Nov. 13, 2002

To: From: Stan Lyles
FCC Application Processing Branch

Re: FCC ID GM3WLPC24HN
Applicant: Psion Teklogix Inc
Correspondence Reference Number: 24275
731 Confirmation Number: EA235972

< Various miniature near field probes >

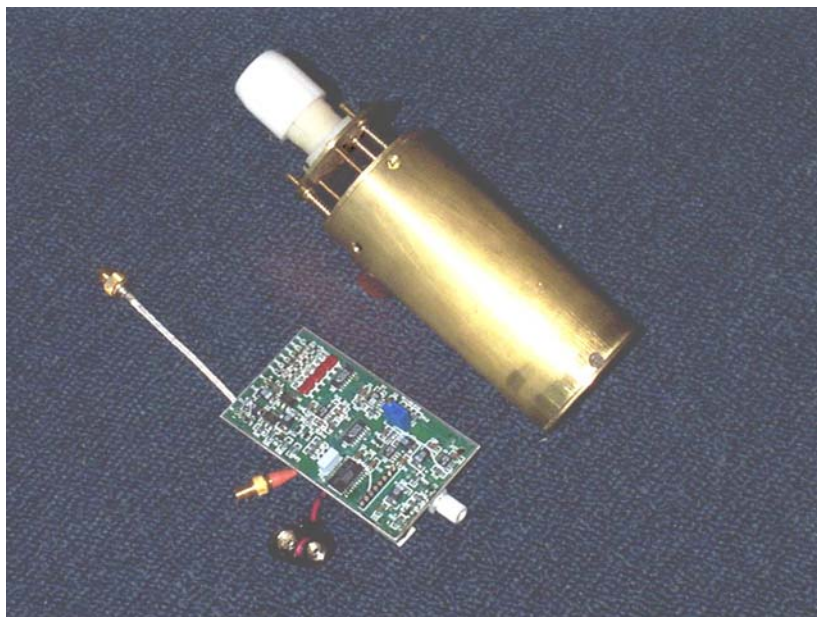
- 1) Additional photographs. Please provide photographs of the SAR measurement system, and key steps of the probe calibration process.

Key steps of probe calibration process are described in the chapter 5.6 and chapter 5.7 of the report.

Conversion Factor for muscle tissue

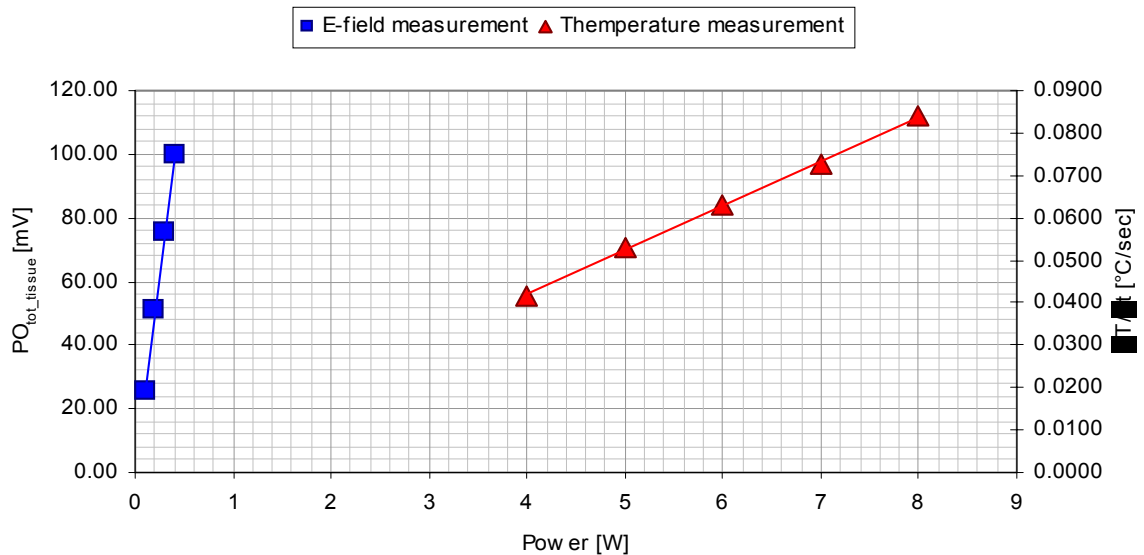
- 2) Statement justifying use of the probe calibration with different tissue parameters than used for testing (body vice head). Please include an analysis of the expected variation on the SAR value. Alternatively please provide data using a probe calibrated with the tested tissue parameters.

The conversion factor calibrated using tested tissue (γ_{muscle} : 4.028, $\zeta_{\text{muscle@cal}}$: 0.166 [W/Kg/mV]) is found to yield approximately 10% lower SAR result than that calibrated using the brain tissue (γ_{brain} : 3.653, $\zeta_{\text{brain@cal}}$: 0.183 [W/Kg/mV]). As a result, the SAR values in the report were overestimated by the ratio of 10%.
